AS-BUILT PLAN  
BY KORMX, INC.  
AS PER NOTES

As Built 5/09/23 B.O

LEMON ST. IMPROVEMENTS  
FOURTEENTH ST. TO TENTH ST.  
ADA IMPROVEMENTS  
HORIZ. SCALE: 1"=40'

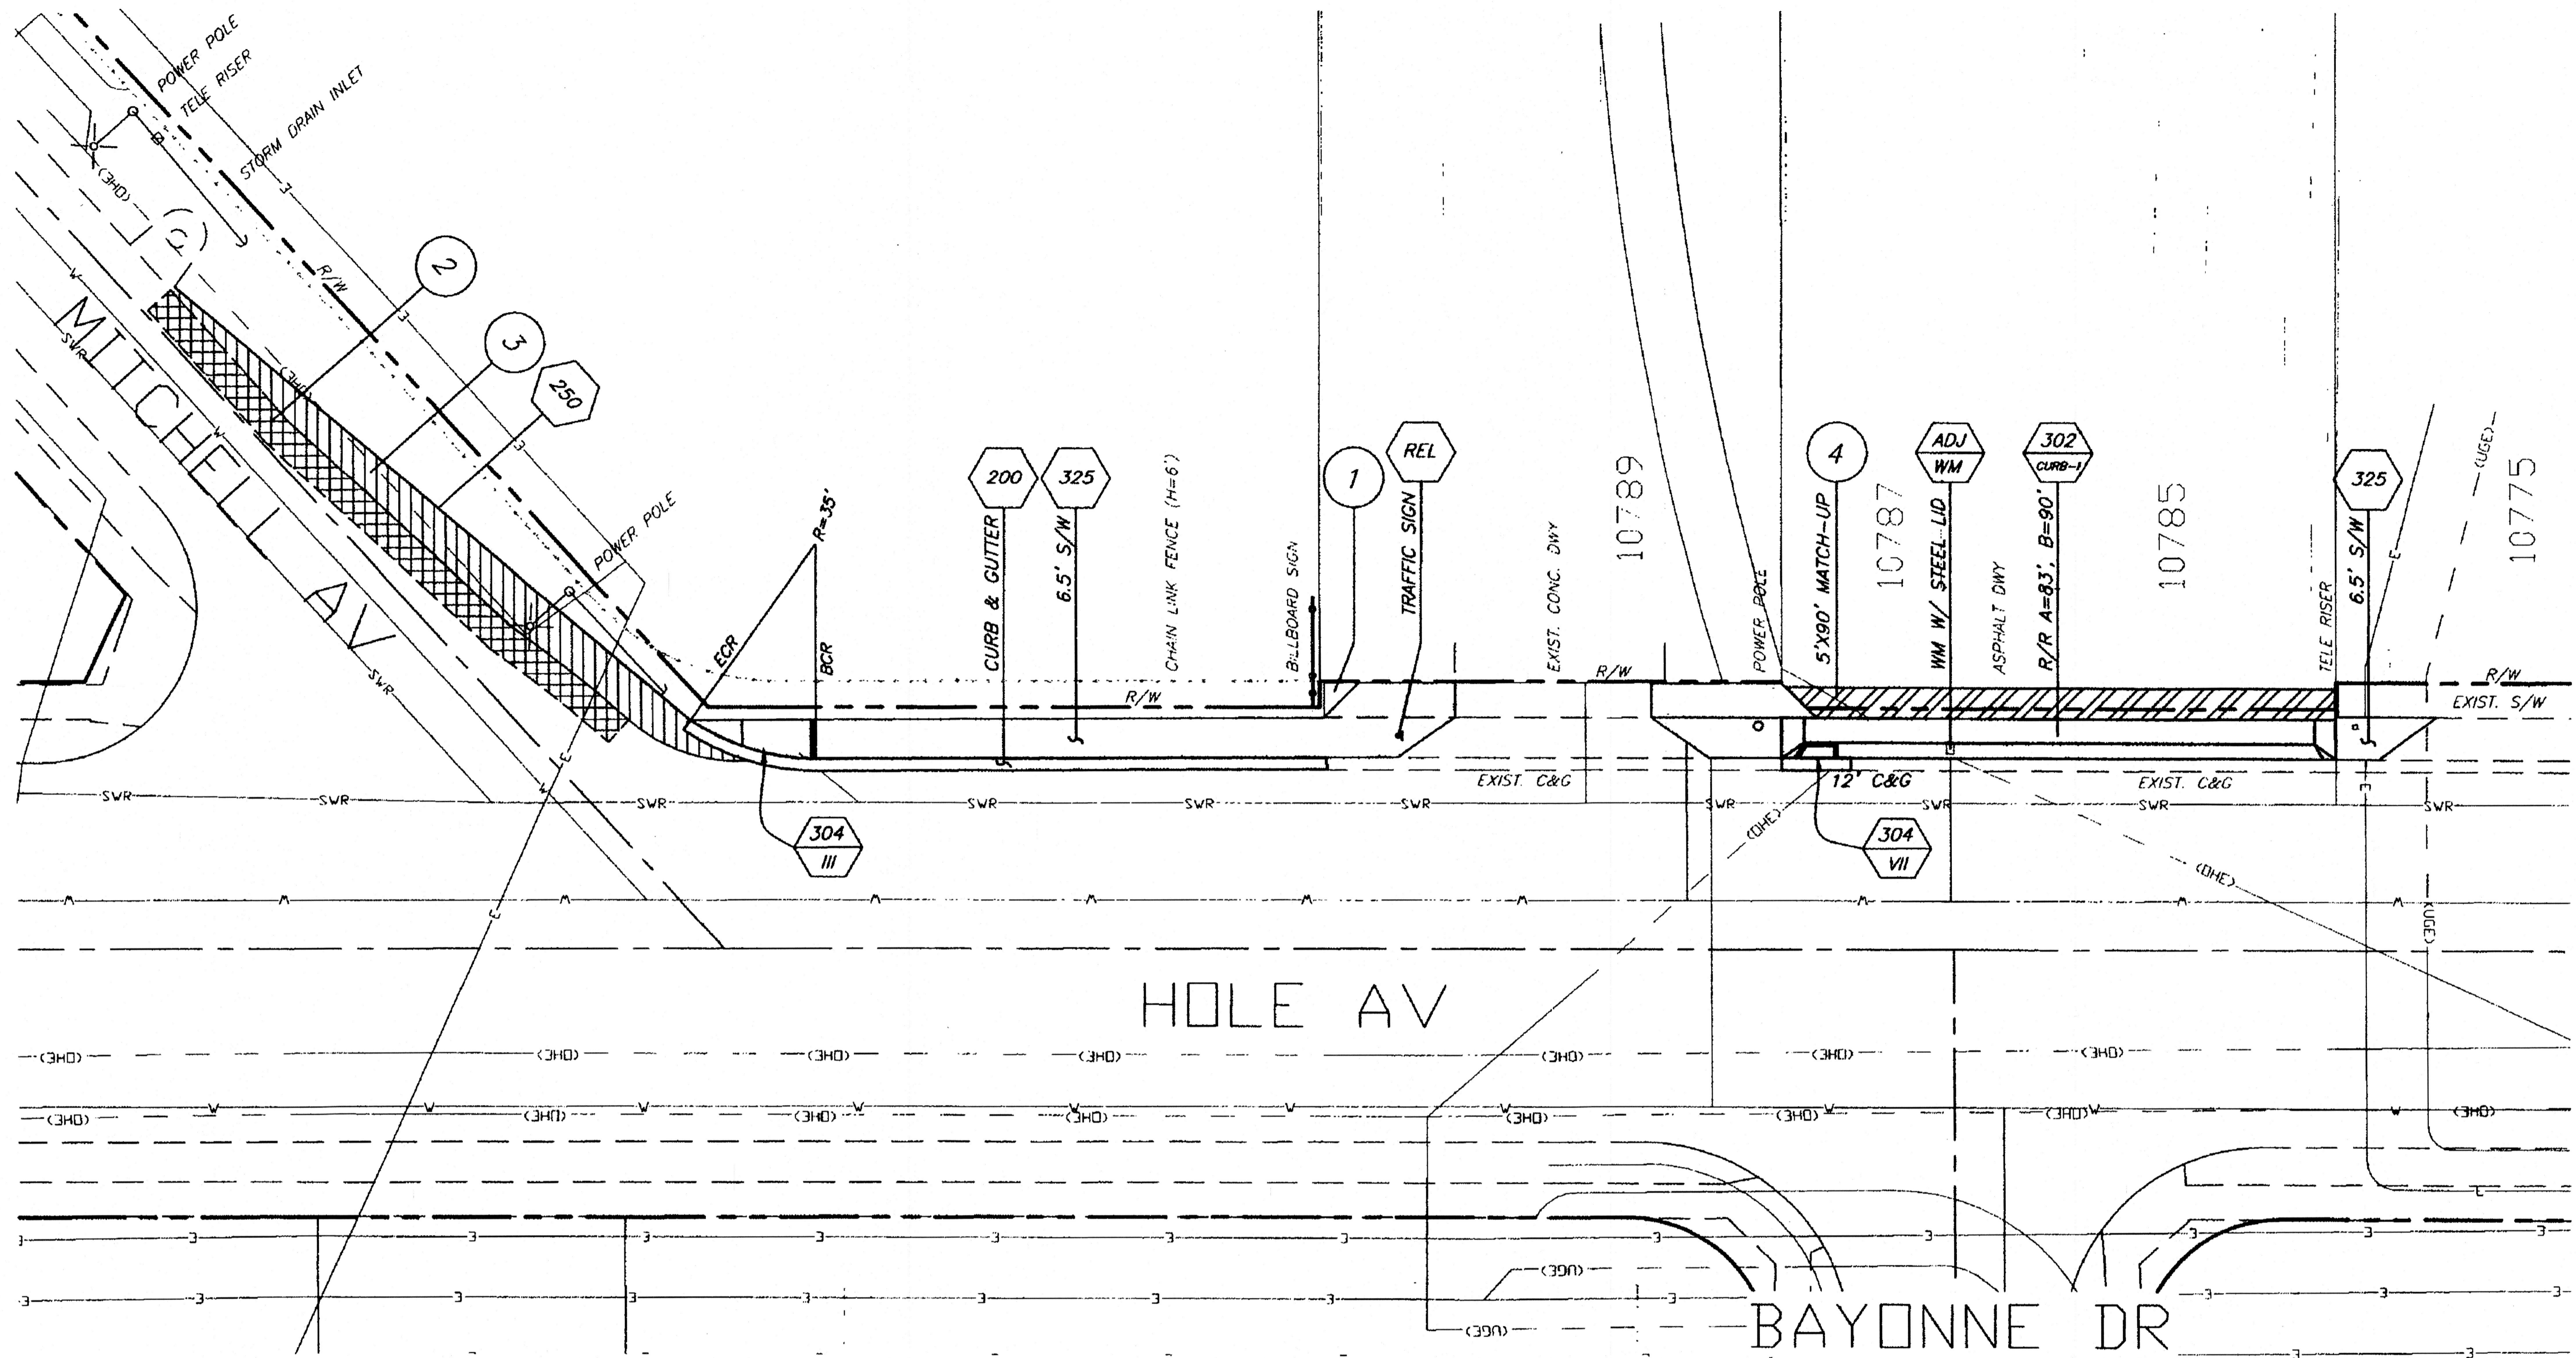
- ADDED Location 1 - Hole and Mitchell Av (See exhibit 2)
- ADDED Location 2 - Hole Av and California Av (See exhibit 2)
- ADDED Location 3 - Sherman Dr and Garfield St (See exhibit 3)
- ADDED Location 4 - Juniper Av and Birch St (See exhibit 4)
- ADDED Location 5 - Redwood Dr and Glenwood Dr. (See exhibit 5)
- ADDED Location 6 - Pine St and Second St (See exhibit 6)
- ADDED Location 7 - Harrison St and Bellavista Av (See exhibit 7)
- ADDED Location 8 - Fifth St & Lemon St (See exhibit 8)
- ADDED Location 9 - Phoenix Av and Arlington Av (See exhibit 9)
- ADDED Location 10 - Crest Av and Beau Av (See exhibit 10)

NO WORK PERFORMED  
DUE TO MACADAM MATERIAL  
W/C RAMP ONLY
